WESTERBEKE

SERVICE BULLETIN 92

SUBJECT: Troubleshooting Water Temperature and Oil Pressure Gauges

HEATER BELOW ENGINE

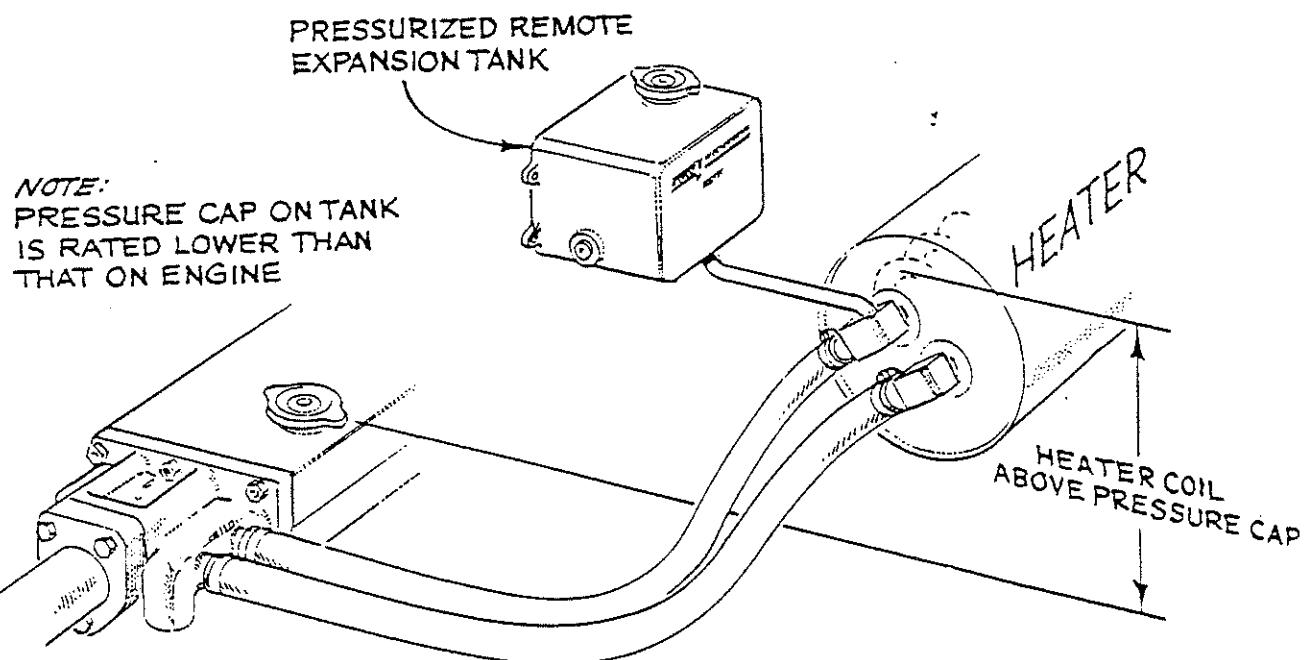
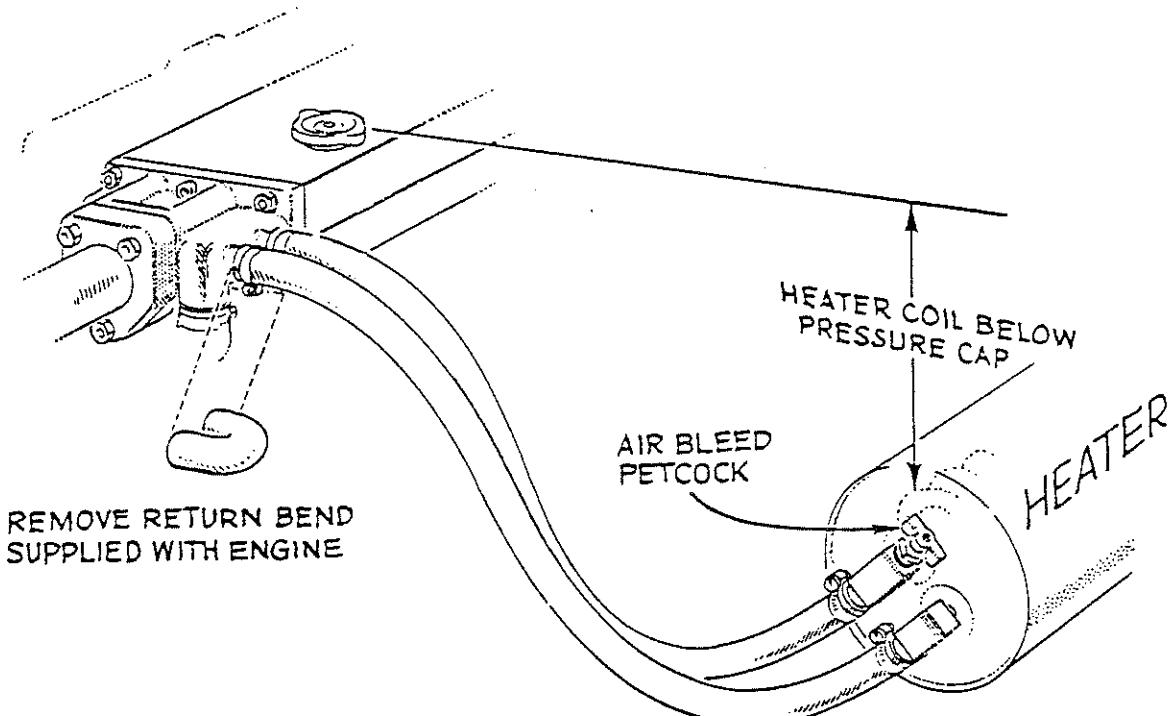
Installation: Remove the returnbend which normally connects the 7/8" hose spuds on engines as shipped from the factory. Connect these spuds to the heater with 7/8" ID wire inserted hose. The spud marked "out" indicates the flow from the engine and the spud marked "in" indicates the flow returning to the engine.

Hoses should rise continuously from their low point at the heater and to the engine so that trapped air will rise naturally from the heater to the engine. If trapped air can rise to the heater, then an air bleed petcock must be installed at the higher fitting at the heater for bleeding the air while filling the system. Avoid loops in hose runs which will trap air.

If any portion of the engine cooling water circuit to or from the heater rises above the engine's own pressure cap, then the pressurized remote expansion tank must be installed in the circuit to be the highest point. The tank kit Part Number is 24177. Install the remote expansion tank in a convenient location such as a sail locker for ease of checking fresh water coolant level.

ILLUSTRATION

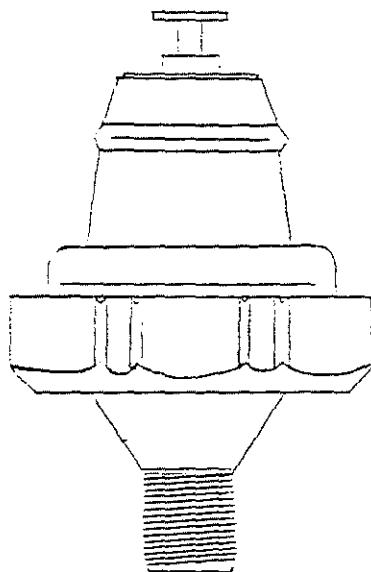
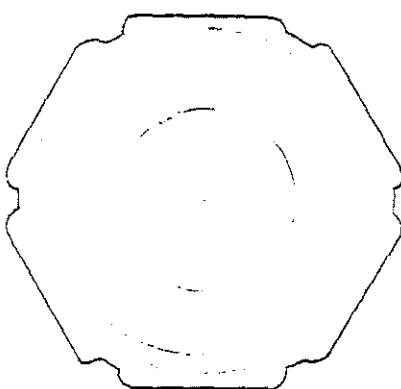
When removing and installing oil pressure switches of the type illustrated below, care should be taken to use the correct type socket specifically designed to correctly fit the metal circumference of these switches.

The correct socket can be acquired through well-known tool manufacturers such as Snap-On, New Britain, Cromwell, Proto and others. The use of channel lock pliers, vise-grips or pipe wrenches, is not advised, in that they may cause damage to the seal between the metal body and the plastic center insert, resulting in a leak and/or switch failure.

Minimum Travel (inner hole used)

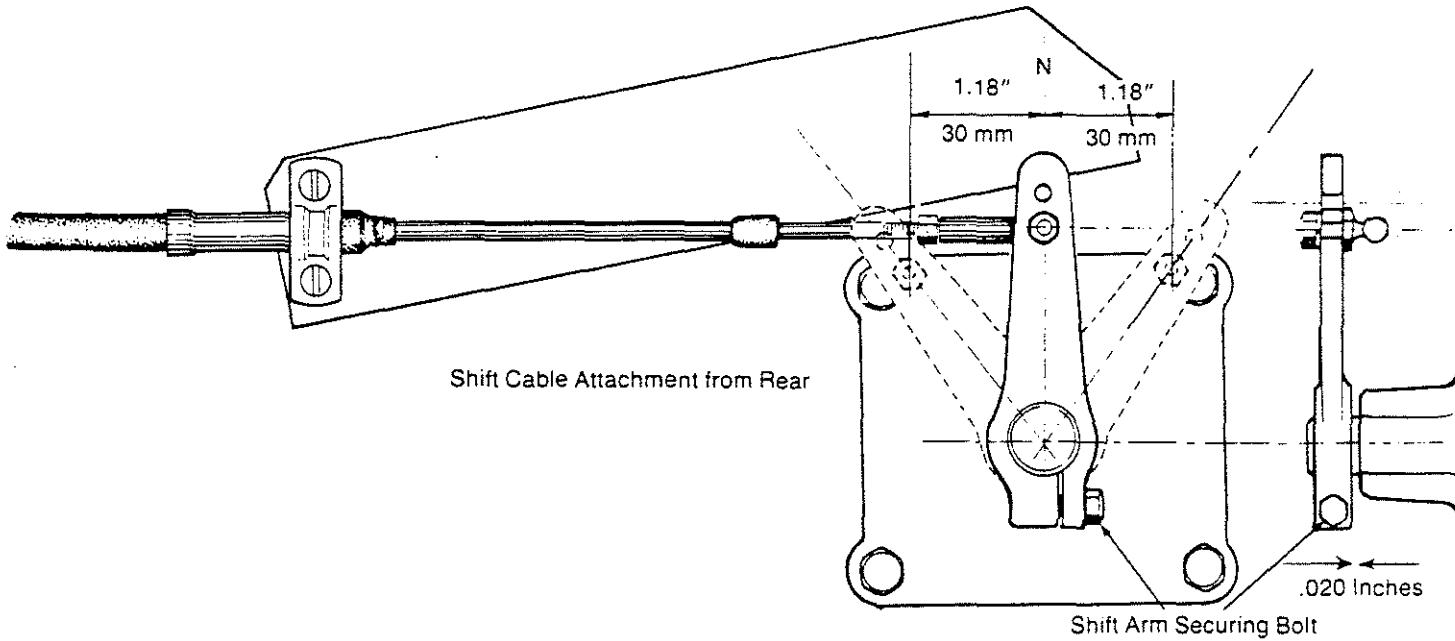
The control cable, when attached to the transmission shift arm ball joint connector, should be attached so as to be at a 90° angle with the lever and transmission in the neutral position (Ref. Illustration).

The transmission shift arm can be rotated on the transmission side cover shifting shaft by loosening the securing bolt (13mm) and rotating the shift arm to produce the 90° angle between the arm and the shift cable when the transmission is in neutral. Insure that there is at least .020 inch clearance between the shift arm and the shift cover before retightening the securing bolt.

The shift cable and pedestal control must allow the transmission shift arm to move from the neutral position into the forward or reverse engagement a MINIMUM of 1.37 inches (35mm) when the outermost ball joint attachment hole is used on the shift arm, or 1.18 inches (30mm) when the inner is used. Use of the inner attachment hole is preferred (Ref. Illustration).

Alternator Mounting Kit #256891 Components

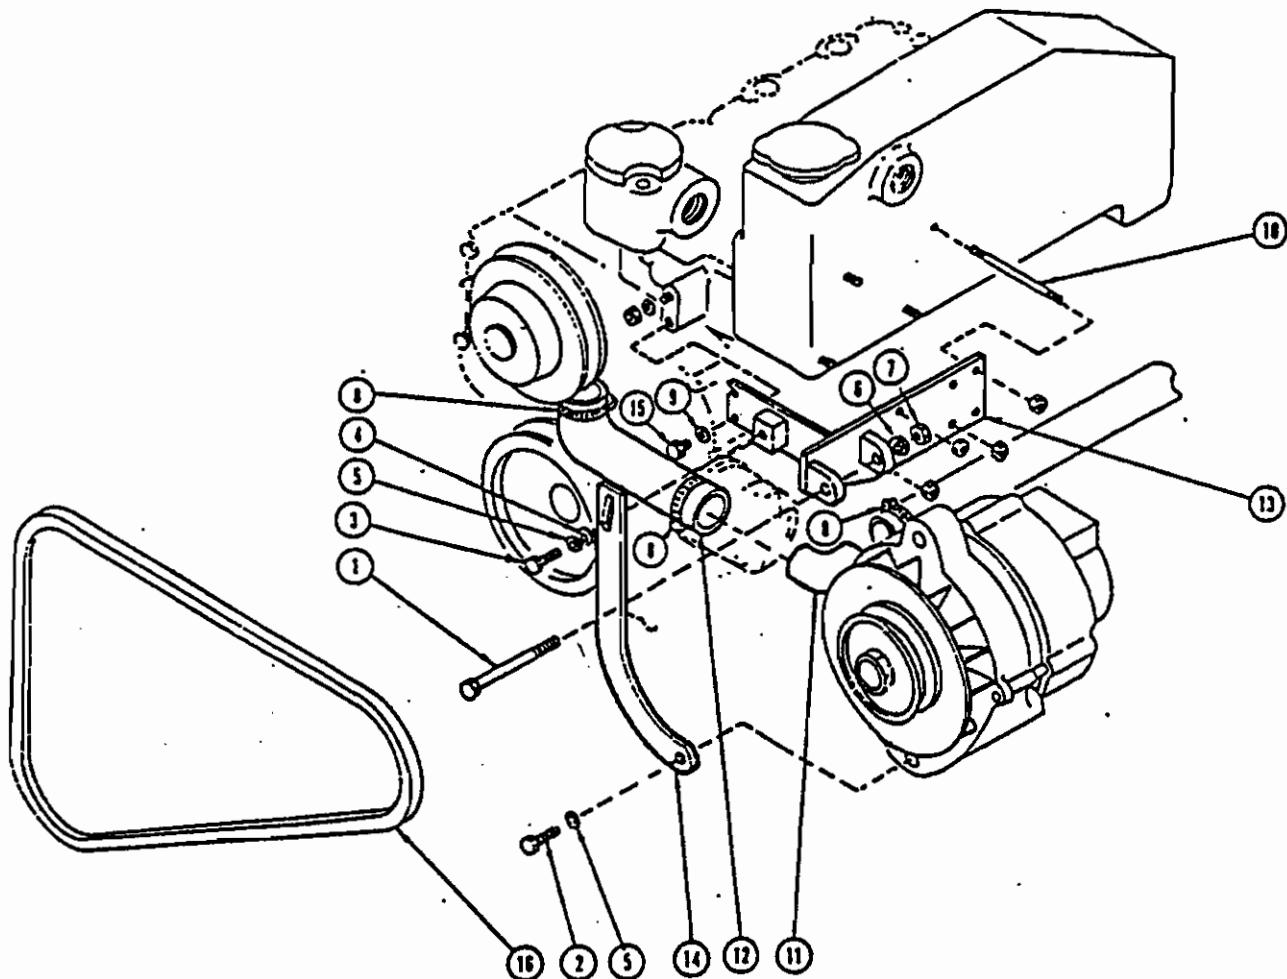
Westerbeke Corporation has become aware that some early model Universal M18, M25 and M25XP marine engines having the DC charging alternator mounted directly to the front gear case cover have experienced failure of the gear case cover at this mounting point.

Owners of these early Universal models are encouraged to inspect their units and if they find the DC charging alternator mounted directly to the front gear case cover that they purchase a conversion kit PN# 256891 that will allow for the mounting of the alternator on a bracket that is attached to the engine's exhaust manifold as later model engines were configured to. The illustration with this bulletin lists the kit components and shows their location on the engine.

Contact your local area Westerbeke/Universal dealer to order the alternator mount conversion kit #256891 and front gear case cover parts as needed.

Heat Exchanger Group - New Style

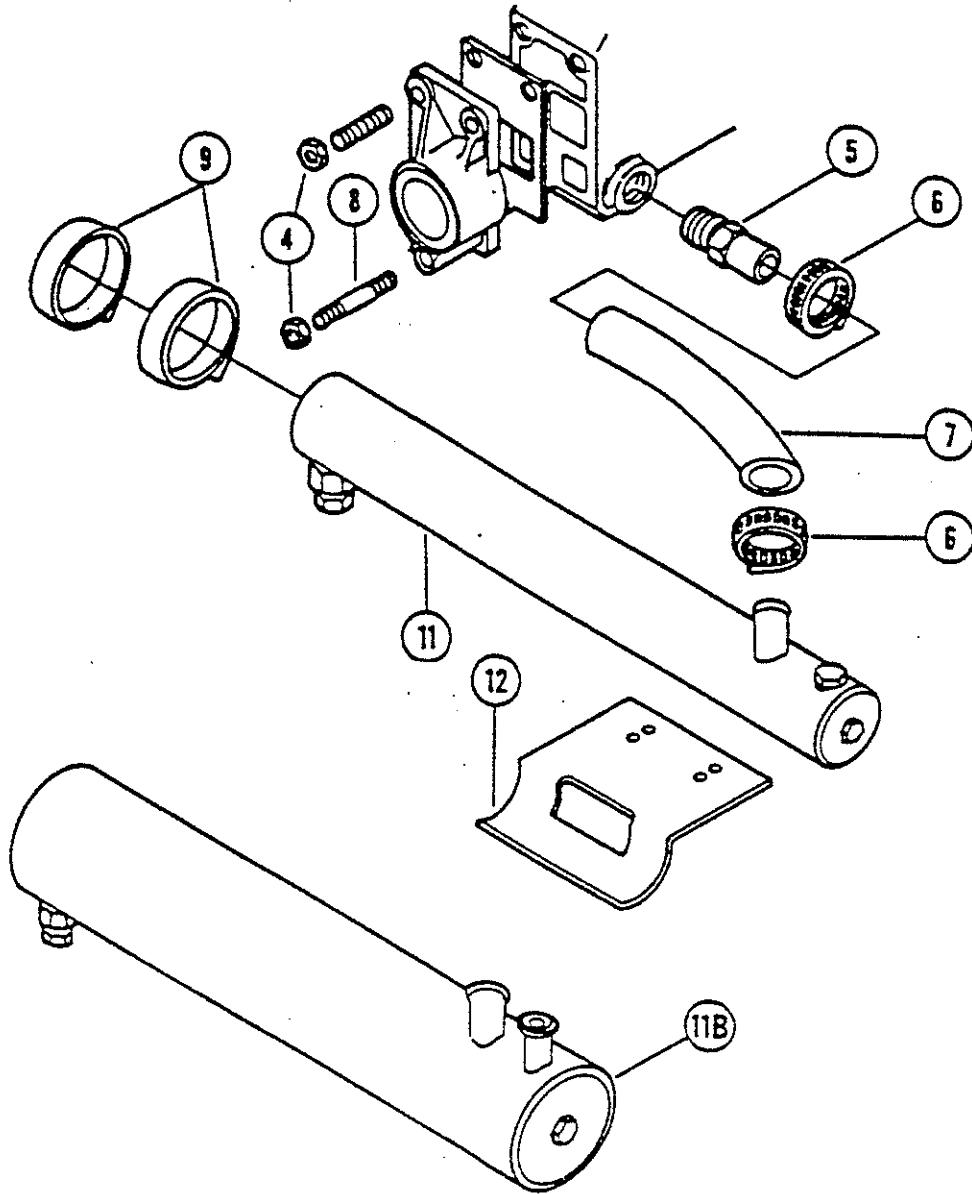
The illustration shows this larger heat exchanger, reference #11B. The contoured mounting bracket reference #12 will have to be reworked to fit the contour of the larger exchanger. This can easily be done by removing the bracket and using a piece of three inch iron pipe as a template to rework the bracket to the proper contour. Use two cushions #033487 between the exchanger body and the bracket along with heavy duty clamps (P/N #303070) when mounting the heat exchanger to the reworked bracket. The illustration helps show these components.

If these areas 1-6 have been inspected and any faults that are found are corrected and overheating still occurs, it is recommended that the operator consider replacing the two inch diameter heat exchanger (P/N #299049) originally supplied with the engine with the three inch diameter heat exchanger Universal incorporated on later models (P/N #299835).

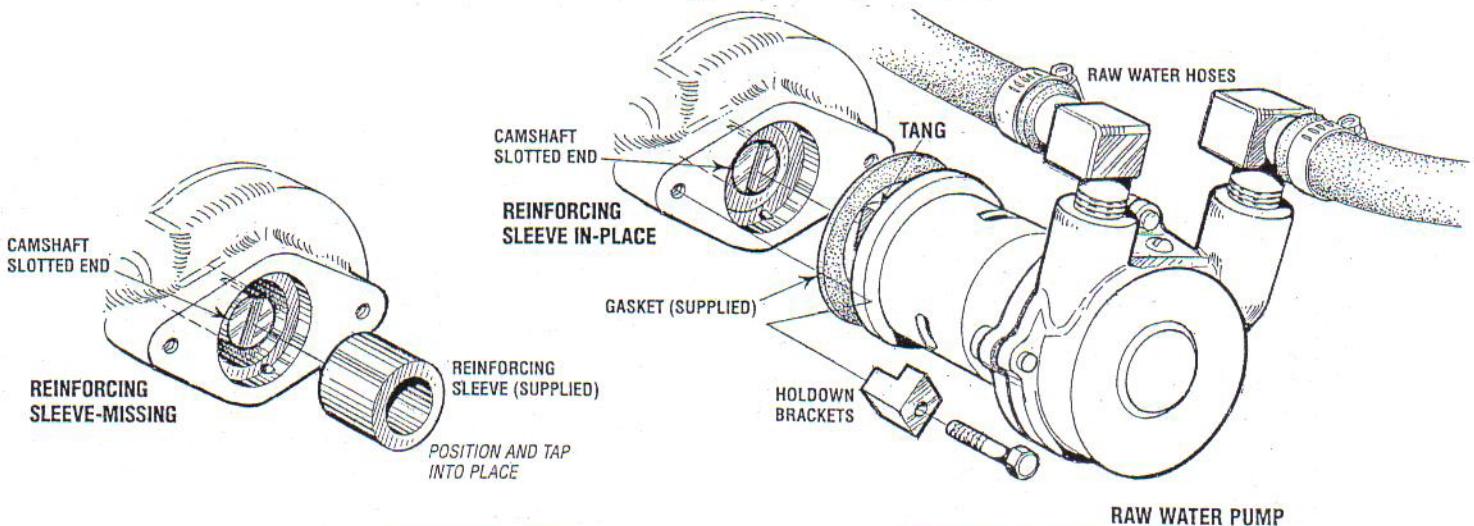
These failures are related to early production models and it has been found that the sea water pump drive tang reinforcing sleeve had not been installed.

Owner/operators are advised to immediately remove the sea water pump off the front gear case of their engine and inspect the cam shaft sea water pump drive end to make sure it has this reinforcing sleeve. The illustrations show the cam shaft end with and without the reinforcing sleeve.

The reinforcing sleeve is easily installed as it is just a slight force fit fully over the sea water pump drive end of the cam shaft. Position the reinforcing sleeve squarely onto the end of the cam shaft and gently tap/push it fully onto the shaft end so it is flush with the end of the shaft.

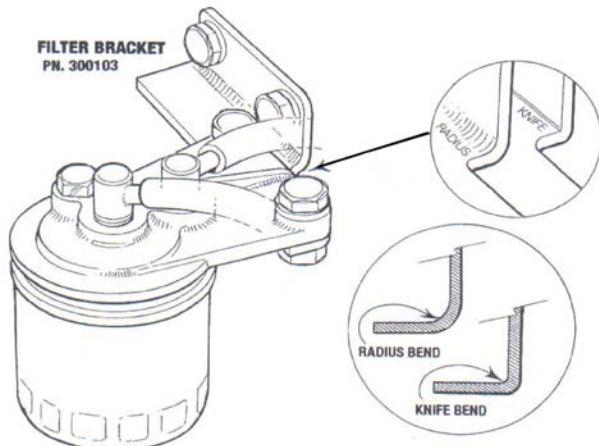
DETAIL: FRACTURES HAVE BEEN REPORTED FROM THE FIELD IN THE AREA OF THE 90-DEGREE BEND IN THE #300103 BRACKET. INSPECTION OF BRACKETS RETURNED FROM THE FIELD HAS SHOWN THAT THE 90- DEGREE BEND WAS INCORRECTLY PERFORMED USING A KNIFE-EDGE BENDER RATHER THAN A RADIUS BENDER.

THIS KNIFE EDGE BENDING PROCESS PLACES A NOTICEABLE CREASE ALONG THE BEND WHICH CAN STRESS THIS AREA OF THE METAL CREATING THE POSSIBILITY OF A FRACTURE TAKING PLACE ALONG THIS CREASE.

THE ILLUSTRATION BELOW SHOULD HELP TO SHOW THE DIFFERENCES IN THE 90 DEGREE BEND.

THE ABOVE SUBJECT MODELS USING THIS BRACKET MANUFACTURED PRIOR TO SEPTEMBER 2004 (E409) ARE SUSPECT. VISUALLY INSPECT THE BRACKET AND IF A CREASE IS VISIBLE ALONG THE BEND AREA. CONTACT WESTERBEKE CORPORATION AT 508-823-7677. PROVIDE THE ENGINE MODEL AND SERIAL NUMBER AND A SHIPPING ADDRESS AND A REPLACEMENT BRACKET WILL BE SENT AT NO CHARGE.

CYLINDER HEAD GROUP

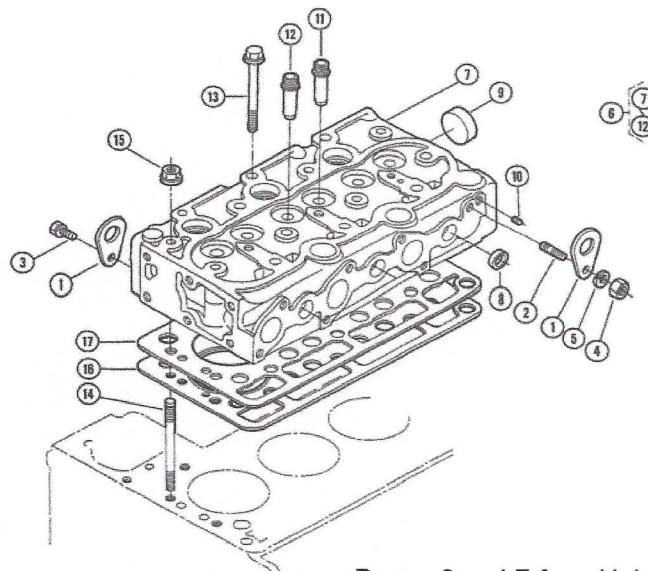
DETAIL: Confusion regarding when to use the cylinder head shim, reference 17 illustrated below, included in complete or upper gasket sets for the M25 and M25XP products has prompted the following explanation of when use of the shim is required.

Upon assembly of the engine by the manufacturer the cylinder head to piston top height clearance is measured to determine if a shim is needed. This results in inconsistency from one engine to the next. When replacing the cylinder head gasket on the subject models pay attention to whether a shim was originally used. Be sure to use the new shim if one originally existed in order to avoid the possibility of interference issues.

In the event you did not disassemble the engine and you do not know if a shim was used originally we recommend both the gasket and shim be installed to avoid problems. Installing a shim in either case is acceptable and preferred.
